California High-Speed Train Project

**RFP No.: HSR 11-16
Design Variance Report**

FRESNO STATION CROSSOVER DISTANCE FROM STATION
HST TRACK ALIGNMENT SPIRAL/VERTICAL CURVE OVERLAP
OCS CLEARANCE ASHLAN AVE
OCS CLEARANCE UNDER FUTURE RECONSTRUCTED FRESNO YARD OVERHEAD

DESIGN VARIANCE COVER SHEET

Clinton Avenue - Exhibit 4

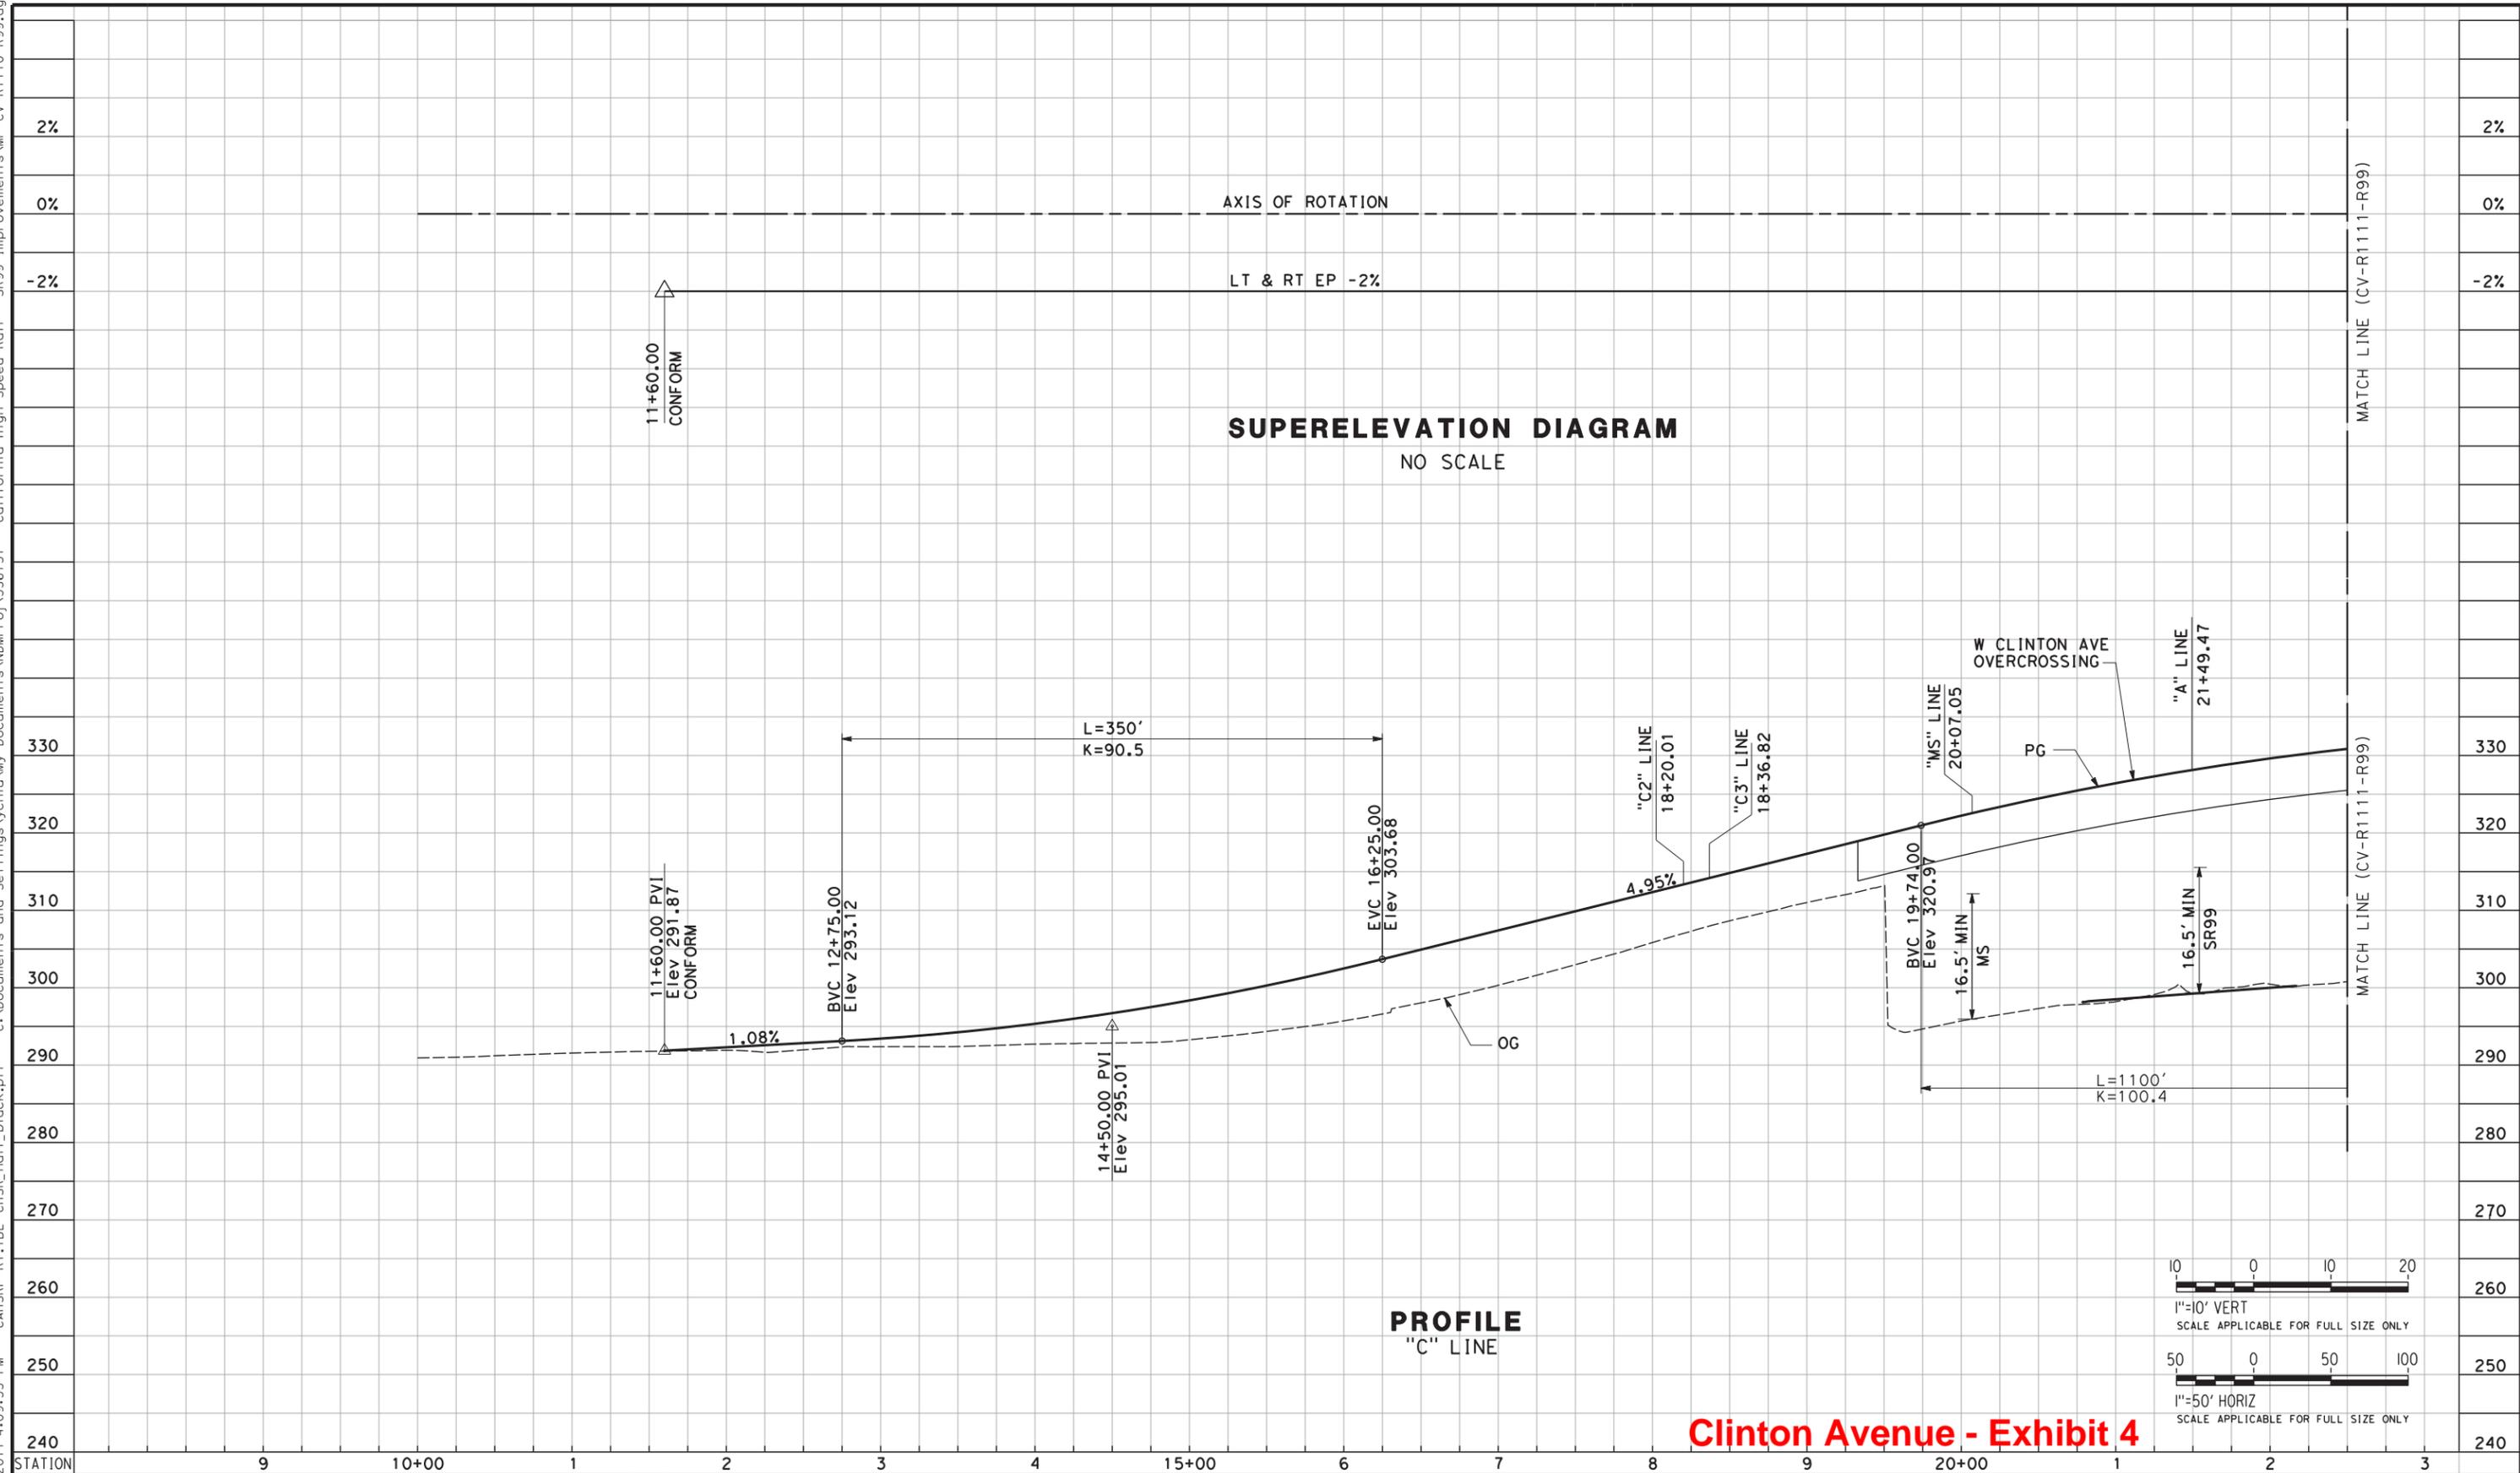
<p>used to meet the flood elevation requirements.</p> <p>Current draft 30% roadway design, as shown in Exhibit 4 is based on current mapping. It should be noted that as a result of the poor accuracy of the initial mapping (+/- 3 ft accuracy), lower clearance was discovered when using the updated mapping. The current draft 30% design has already adjusted the roadway profile and HST profile to provide additional 1 ft clearance due to the initial mapping accuracy issues.</p> <p>Subsequent evaluation and adjustment of the 30% profile design were conducted based on :</p> <ul style="list-style-type: none">• Updated mapping (+/- 0.5 ft accuracy)• Estimated flood elevation requirement <p>Based on FEMA evaluations and maps, 100 year flood event will impact regions near San Joaquin River, Herndon Canal and south of Clinton. <u>Local area adjacent to Clinton Ave. is therefore subject to only localized flooding for which flood agencies use 6 inch water elevation above existing ground/Golden State Blvd..</u> At Clinton crossing, existing ground is at 297.5 ft. Allowing for 0.5 flood elevation (i.e. elevation 298), TOR at 2.5 ft higher will be at minimum elevation of 300.5 ft.</p> <p><u>A track profile with 24 ft clearance below the Clinton overhead structure, will meet flood elevation requirements with no need for boat section.</u></p> <p><u>C-DVR 25.5 ft clearance, w/ 1.5 ft deep Wall/Boat Section</u></p> <p>The draft 30% HST track profile design shown in Exhibit 4, provides for an intermediate option of 1.5 ft higher 25.5 ft clearance over HSR tracks, by lowering the profile.</p> <p><u>The estimated flood elevation will impact the current 30% design with the DVR 25.5 ft clearance condition, requiring a 1.5 ft wall/boat section.</u></p> <p>As shown in exhibit 7, the draft 30% design HST profile (in black) will have TOR below minimum 300.5 ft level to clear flood elevation requirement, for nearly 1000 ft North of Clinton. This is primarily due to the HST profile adjustment required due to the initial mapping accuracy/errors. To meet flood elevation clearance requirements, it is proposed to consider wall/boat-section to protect track work</p>

<p>PROPOSED ALTERNATIVE DESIGN REQUIREMENT</p>	<p>Allow minimum clearance under the new replacement bridge to be 24 ft (DVR 24 ft) as permitted condition for existing structures *, which also will avoid the need for walls/boat-sections,</p> <p>OR</p> <p>Allow minimum clearance under the new replacement bridge to be 25.5 ft (DVR 25.5 ft) as permitted condition for existing structures *, as shown in Draft 30%, however will require a <u>1.5 ft walls/boat section</u> and potentially pumping facilities,</p> <p>OR</p> <p>Maintain standard 27 ft clearance, but provide deeper <u>3 ft walls/boat section</u> and potentially pumping facilities</p> <p>* as permitted by TM 3.2.1 for crossing under existing bridges of less than 160 ft width.</p>

Clinton Ave - Exhibit 7

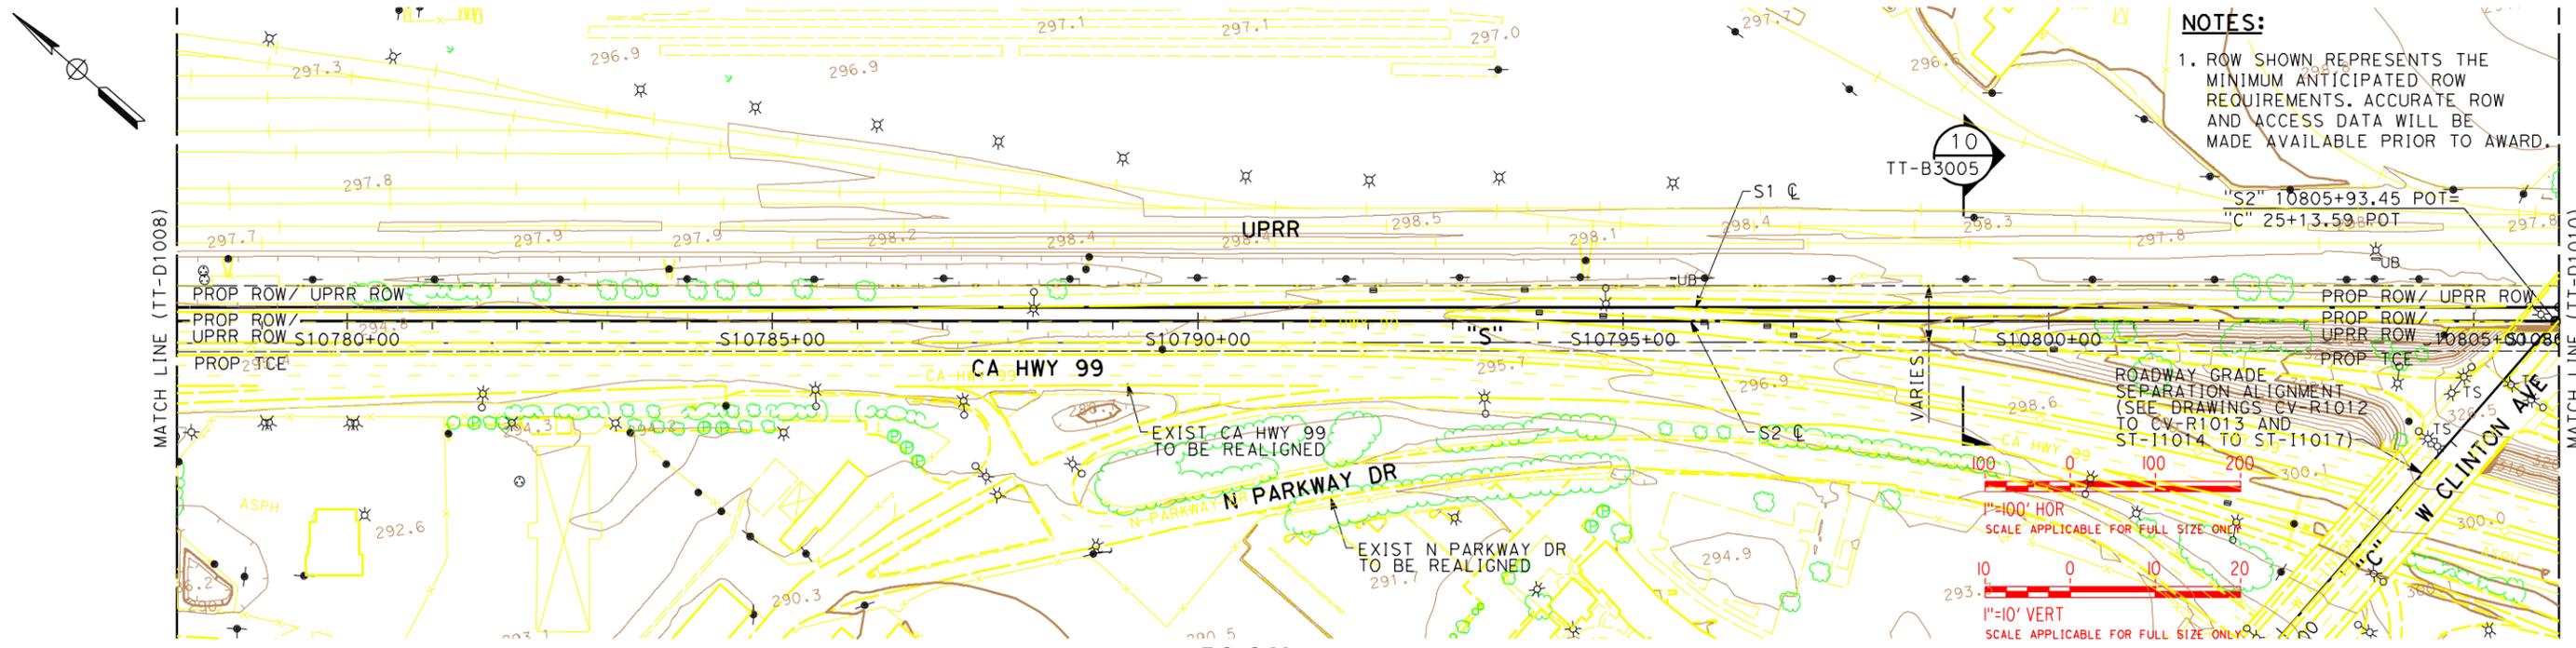
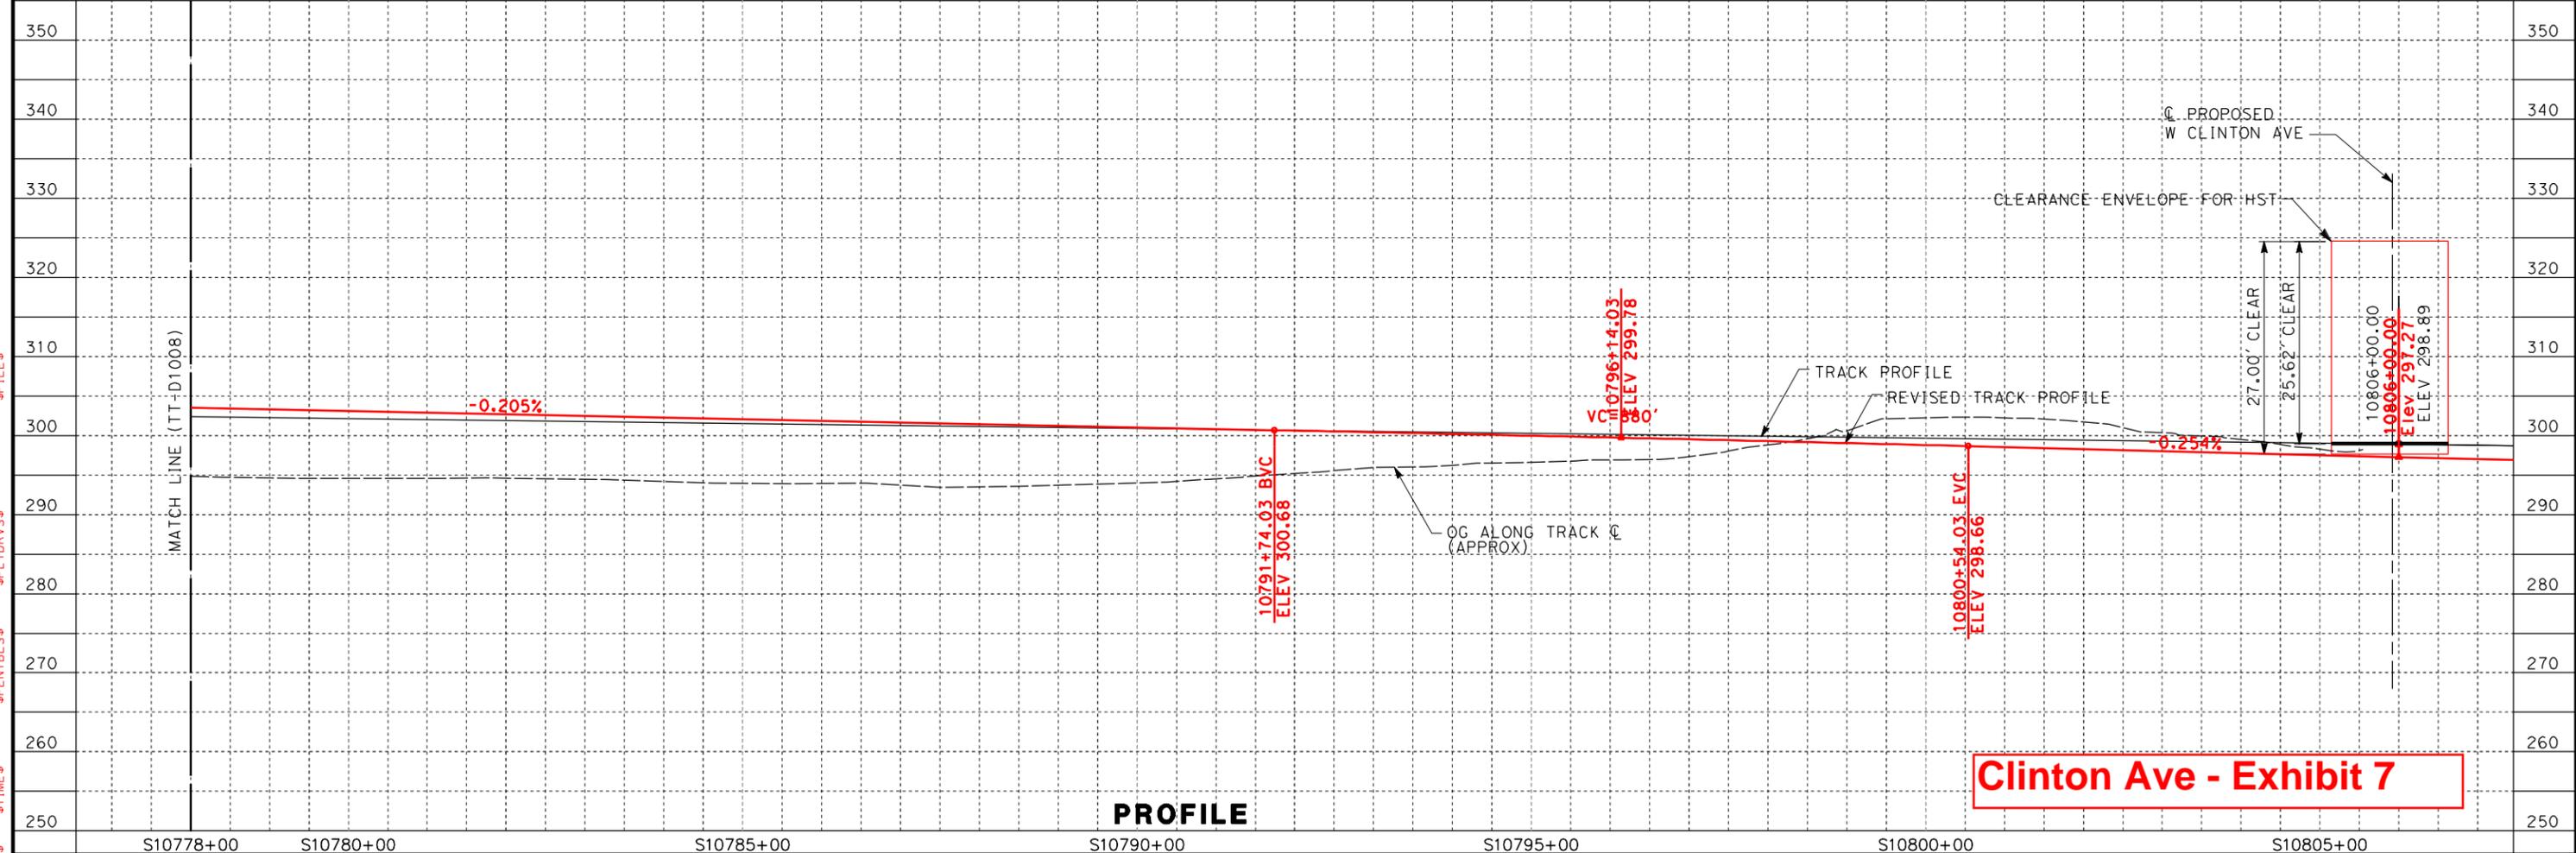
CLINTON AVE					
Structure Depth =	7.33'				
Clearance Check Locations:	STA ("C")	CL ELEV	Offset	EP ELEV	Soffit ELEV
A - NB Track	24+54.58	333.28	61.50	332.05	324.72
B - NB Track	25+52.49	332.97	50.53	331.96	324.63
C - SB Track	24+32.67	333.22	61.50	331.99	324.66
D - SB Track	25+30.57	333.12	50.53	332.11	324.78
Clearance Check Locations:	STA ("S1" or "S2")	TOR ELEV	Vert Clr (Soffit - TOR)		
A - NB Track	10805+28.13	297.98	26.74		
B - NB Track	10806+76.72	298.80	25.83		
C - SB Track	10805+13.71	299.00	25.66 Min		
D - SB Track	10806+62.30	298.82	25.96

25.5' Min Vertical Clearance (Recommended)
